**Village of Spring Valley
200 North Main Street
Spring Valley, New York 10977
845-352-1100**

**Planning Board Agenda
August 31st, 2020
7:00pm**

TO: Village of Spring Valley Planning Board
FROM: Michael D. Kauker, PP, AICP
Principal
DATE: August 28, 2020
SUBJECT: **13-15 Bethune Boulevard**
Review # 5

TO: Village of Spring Valley Planning Board
FROM: Michael D. Kauker, PP, AICP
Principal
DATE: August 31, 2020
SUBJECT: **14 Rose Avenue**
Review # 4

LOT AREA: 150,000 SQUARE FEET
 TAX MAP DESIGNATION: 50.00-1-13
LAYOUT PLAN FOR
14 ROSE AVE

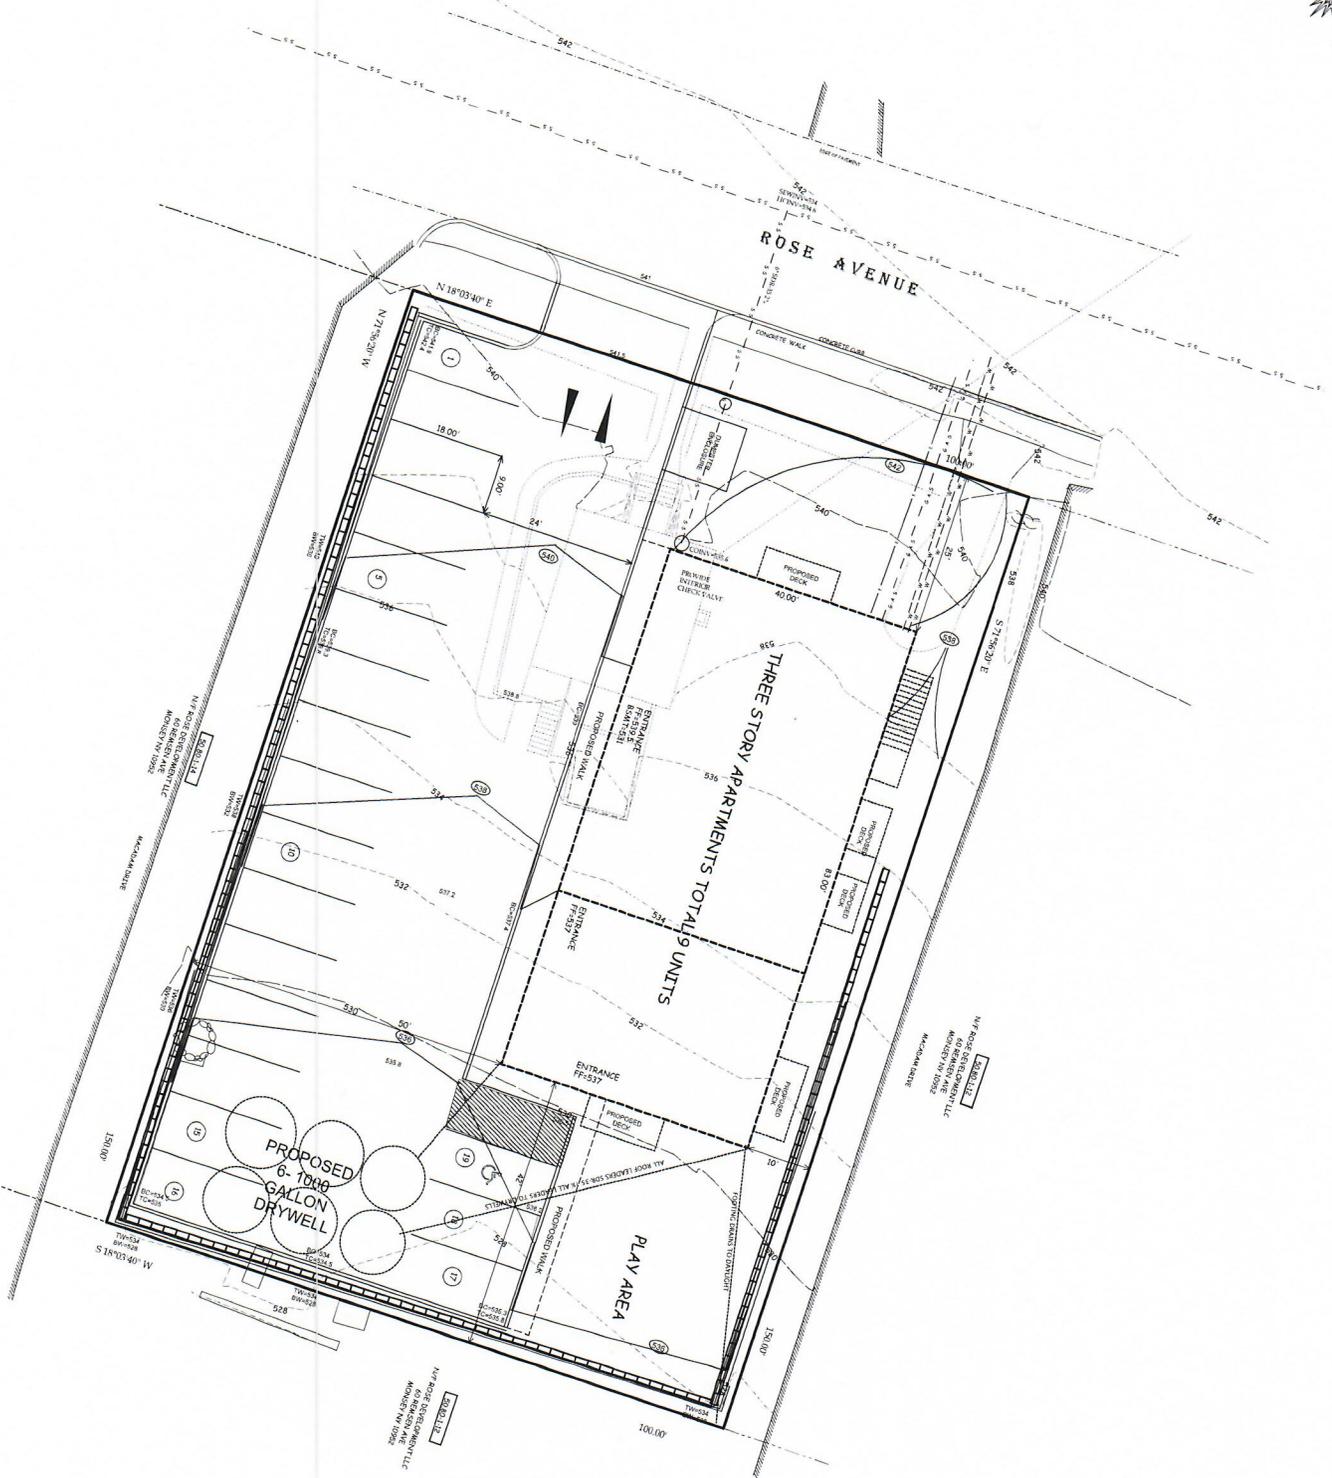
1. The proposed grading and existing conditions should only be shown on site plan sheets that relate to those elements. For example, they do not need to be provided on the planimetric plan or landscape and lighting plan among others.

5. The applicant has moved the location of the proposed dumpster from the rear of the building to the front yard. We recommend that the dumpster enclosure be relocated back to its original location to the rear of the building.

6. I would recommend enclosing the play area with a fence for the safety of the children.
7. The applicant should confirm the FAR as there are no calculations provided on the Architectural Plans.

LOT AREA: 15,000 SQUARE FEET
 TOTAL SQUARE FOOTAGE: 50,000 S.F.
LANDSCAPE AND LIGHTING PLAN FOR
14 ROSE AVE
 TOWN OF RAMAPO, ROCKLAND COUNTY
 SPRING VALLEY, NEW YORK
 JUNE 07, 2017 SCALE: 1" = 30'

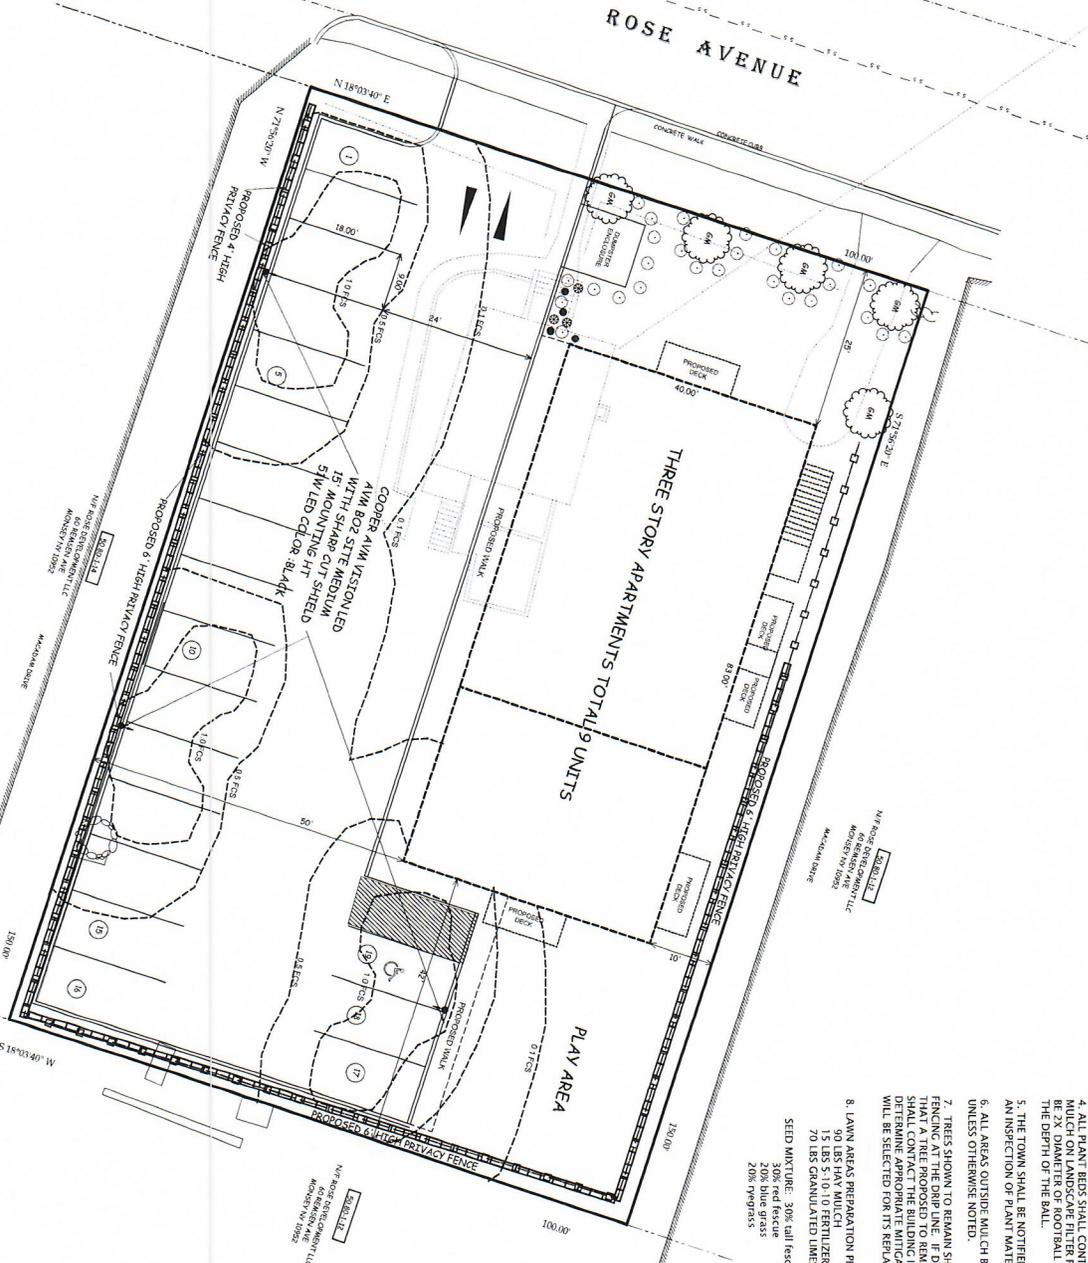
3. Additional landscaping should be provided in the front yard between the building and the street. I would recommend a berm with evergreen trees.
4. I would recommend a more residential type lighting fixture be provided.
